Metropolitan Washington
Council of Governments

Metropolitan Branch Trail Upgrade

Preliminary Design Report
May 2023

Figure 5 - Traditional Asphalt Pavement Section for Shared Use Path (MDSHA 580.08)

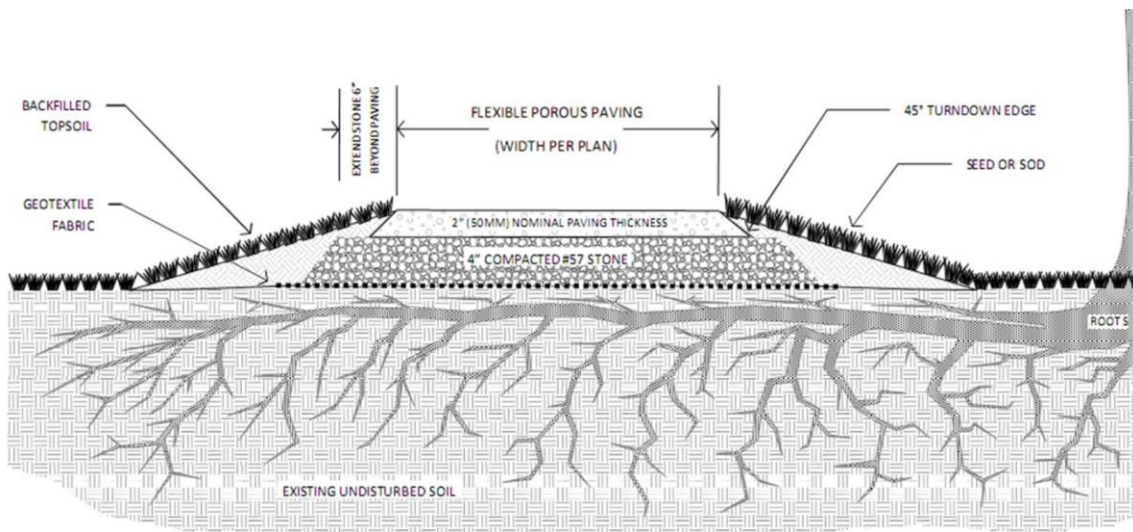
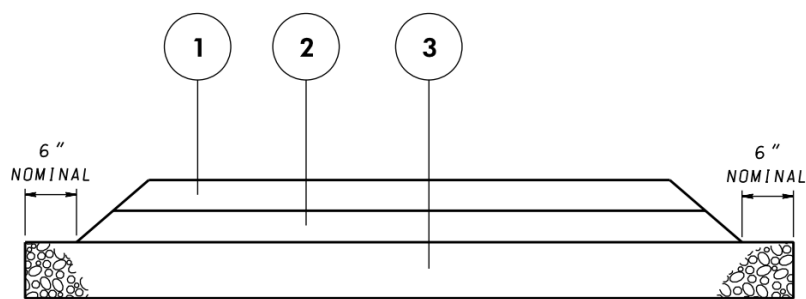
Project:	Takoma COGTLC Metropolitan Branch Trail		
Date:	April 2023		
Reviewer:	MNCPPC		
Comment ID	Sheet No. / Drawing No.	Comment	Response
1	General	The porous flexible paving proposed for this bikeway is not the preferred choice for a regional bikeway/breezeway. Surface should "meet requirements of public road design, [with] surface materials and maintenance practices that maximize surface smoothness and pavement life, minimizing potential for pavement cracking and buckling" (Bicycle Master Plan, p 72). If providing a porous surface, porous asphalt would be consistent with the material used in the District's section of this trail, and a more acceptable choice. However, to maintain the permability of porous asphalt, annual maintainance and cleaning is needed. If that maintainance cannot be provided, then this negates the permability, and a regular asphalt surface material would be a better option. At a minimum, any surface should meet the guidance in the AASHTO Bicycle Facilities Guide (2012) on page 5-25.	Porous flexible paving was recommended (draft 30% design) to help preserve trees and to limit the potential for cracking and buckling of the trail pavement. To clarify, porous flexible paving (not porous asphalt) was used in the District's section of this trail. Continued use of a traditional asphalt pavement for the trail adjacent to established trees still has potential for cracking and buckling. Use of porous asphalt will also require more excavation to install, which may be a concern due to the proximity of adjacent established trees. As directed by the City of Takoma Park, the pavement section was changed from porous flexible paving to traditional asphalt.

ROADWAY PLAN			
SCALE	1"=20'	DATE	MAY 2023
CONTRACT NO.	21-093-TLC		
DESIGNED BY	AMA	COUNTY	MONTGOMERY
DRAWN BY	MEG	LOGMILE	
CHECKED BY	RJG		
F.A.P. NO.	T.B.D.		
DRAWING NO.	HD - 01	OF	06
SHEET NO.	05	OF	16

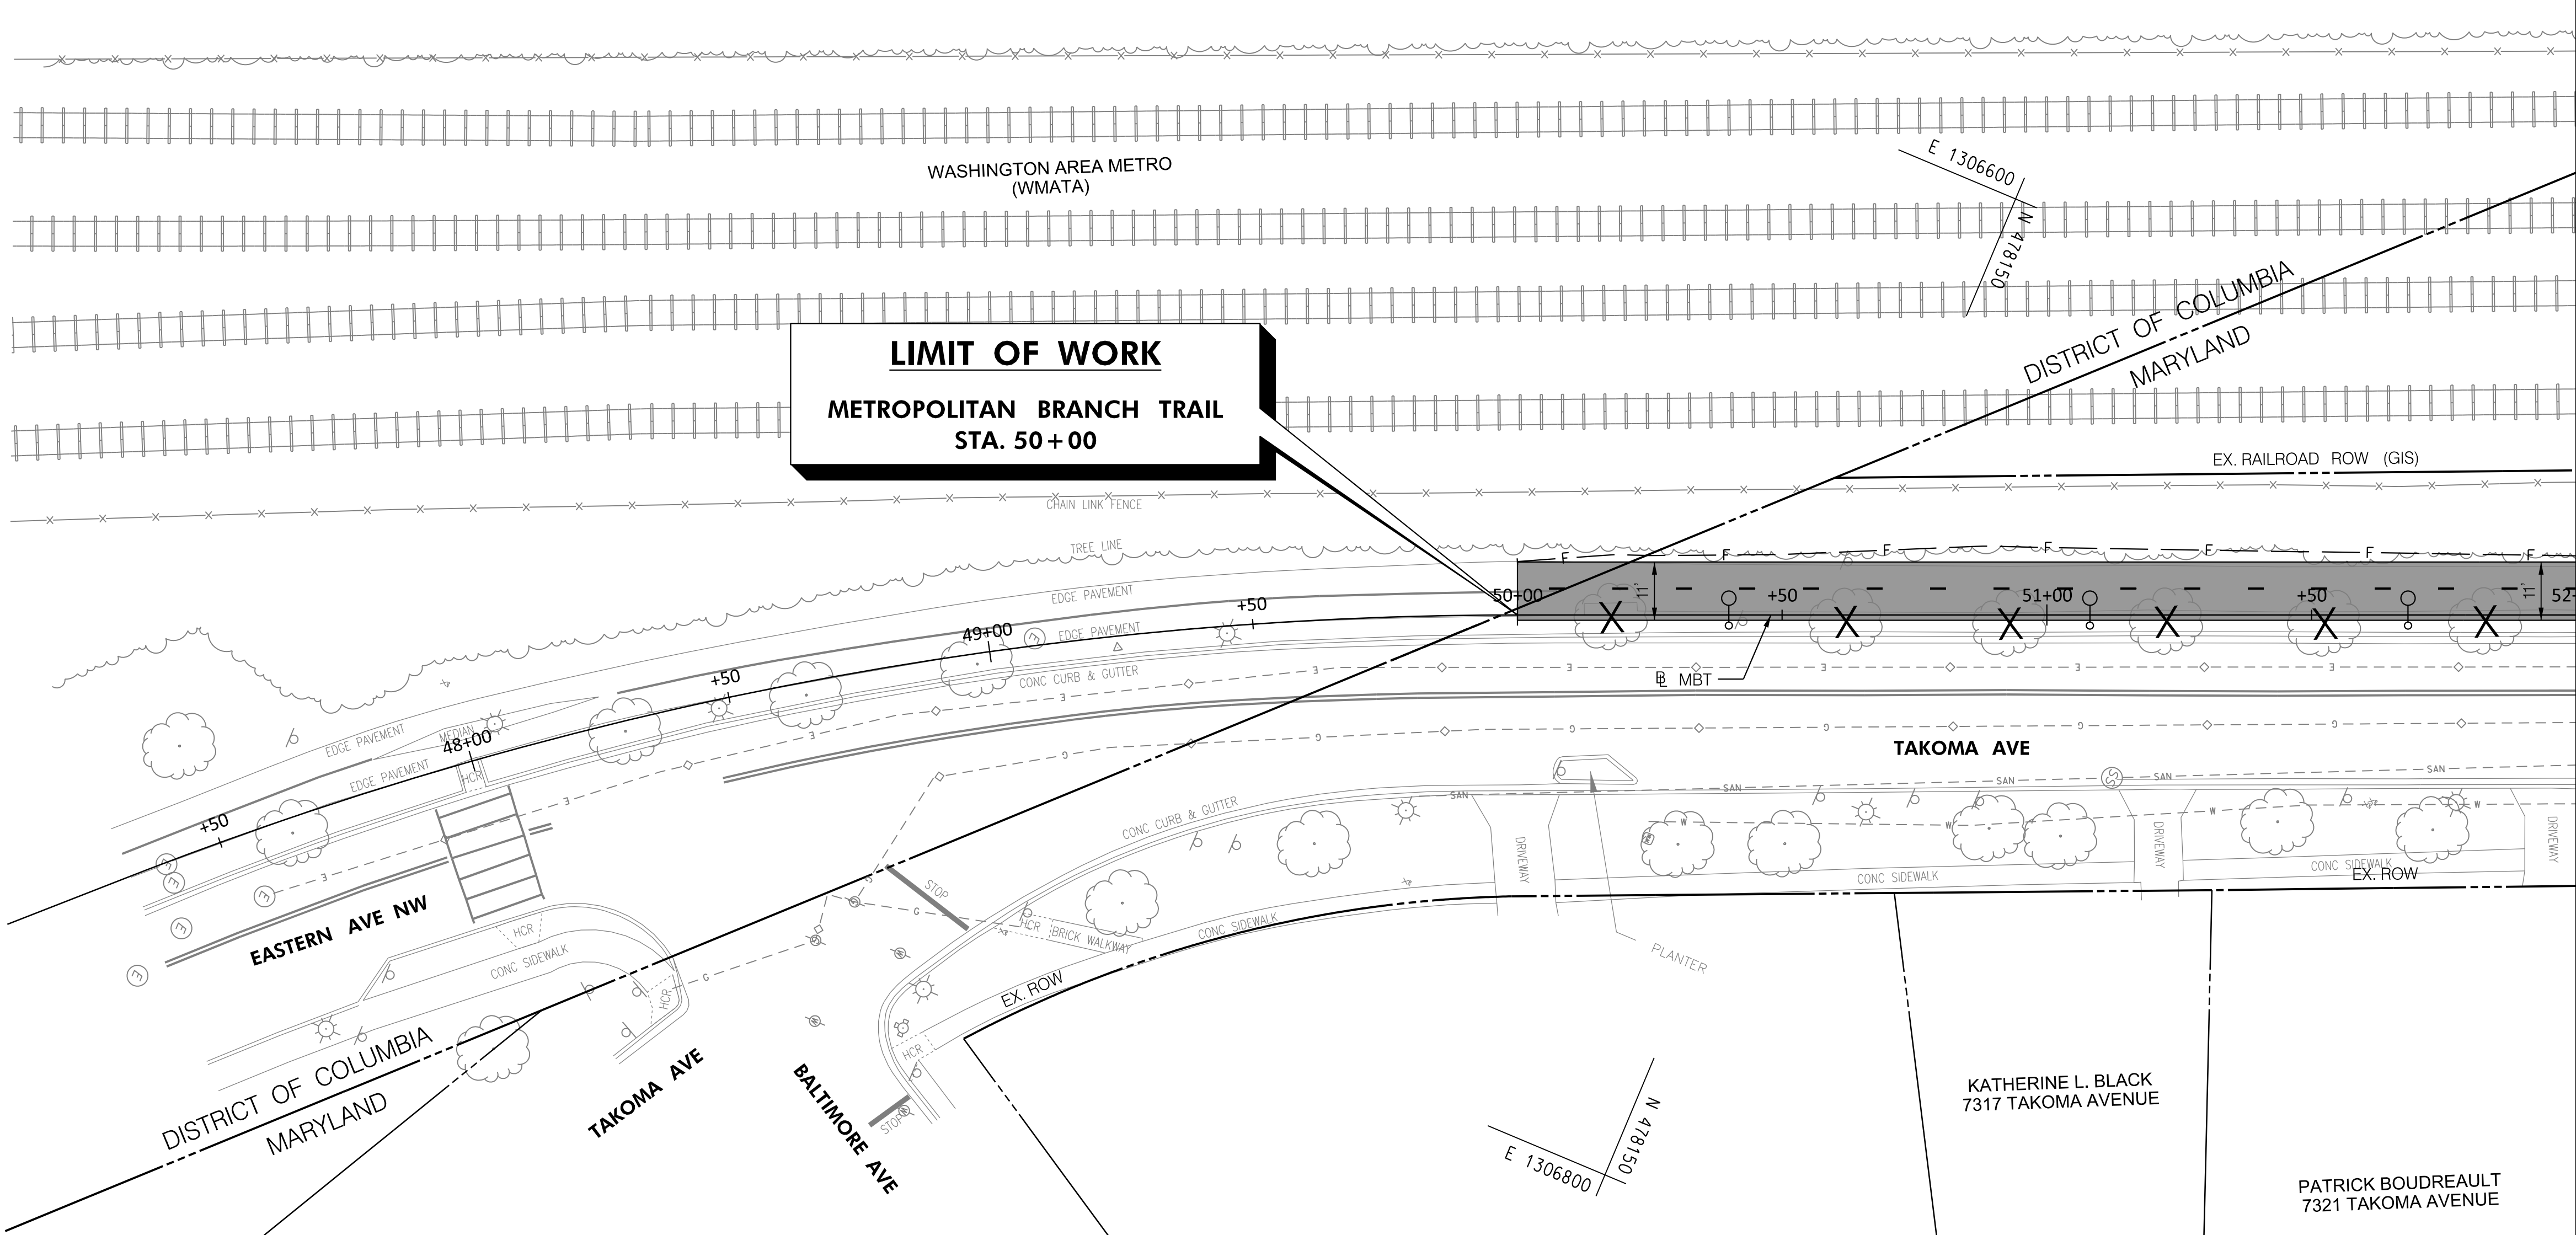
Project:	Takoma COGTLC Metropolitan Branch Trail		
Date:	April 2023		
Reviewer:	City of Takoma Park		
Comment ID	Sheet No. / Drawing No.	Comment	Response
1	HD-01	Public Works expressed concern that having these 'lights' so close to the road invites costly damage from when vehicles bump or collide with them. Would the design work such that they could be placed on the interior? Does that make sense? To me it seem that with the trees, it would be way less likely to happen and they add a note of physical protection to the trail?	It is recommended lighting remains in location shown to avoid unnecessary tree impacts on the opposite side of the trail. Proposed curb will provide protection from vehicles colliding with them.
2	HD-01	Although there is a lot of public feedback in support of porous pavement, PW staff and M-NCPPC staff we spoke with feel strongly that a more durable surface, like asphalt, will be easier and more cost-effective to maintain over time. Apparently it also better aligns with the County's standards for "Regional Breezeways", which this trail has been identified as.	Will use asphalt surface for shared use path.

SCALE	1"=20'	DATE	MAY 2023	CONTRACT NO.	21-093-TLC
DESIGNED BY	AMA	COUNTY	MONTGOMERY		
DRAWN BY	MEG	LOGMILE			
CHECKED BY	R/JG				
F.A.P. NO.	T.B.D.				
DRAWING NO.	HD - 04	OF	06	SHEET NO.	08 OF 16

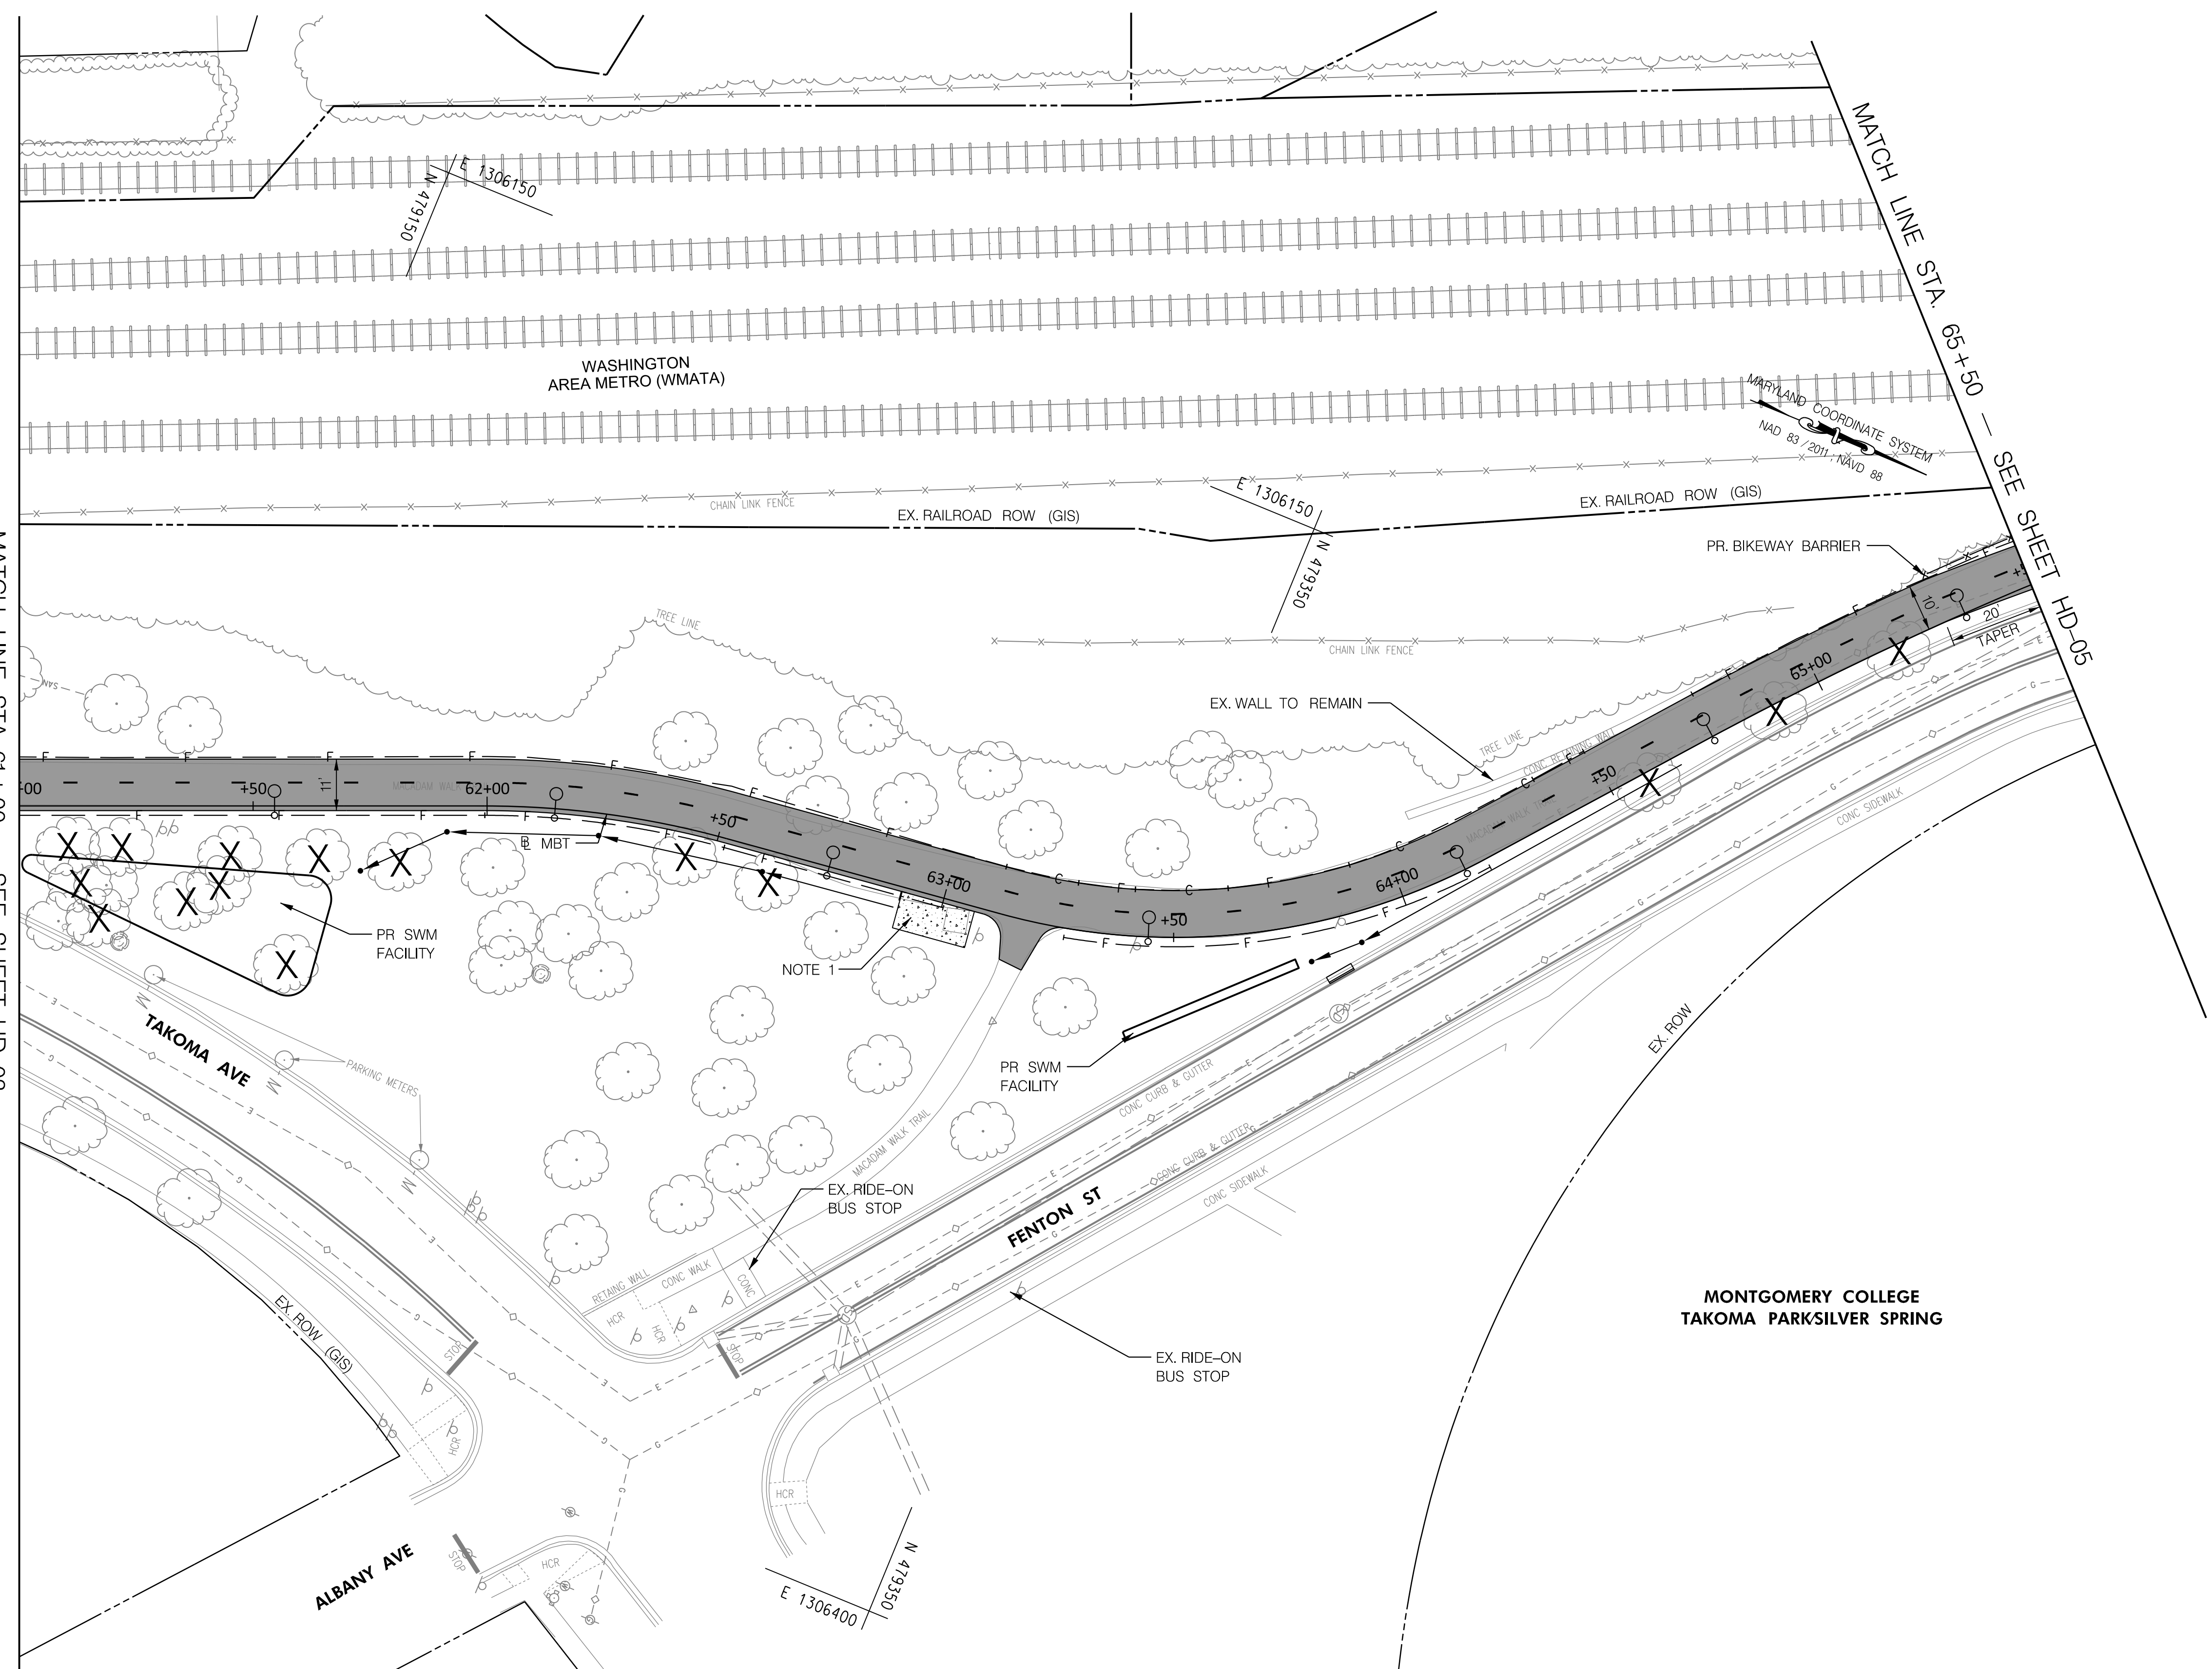
7	HD-04	I also recommend the striping of four-quadrant crosswalks at the intersection of Fenton Street & Takoma Avenue, though I realize that may be out of scope.	This work is outside the scope for this project. Will record comment for future design stages.
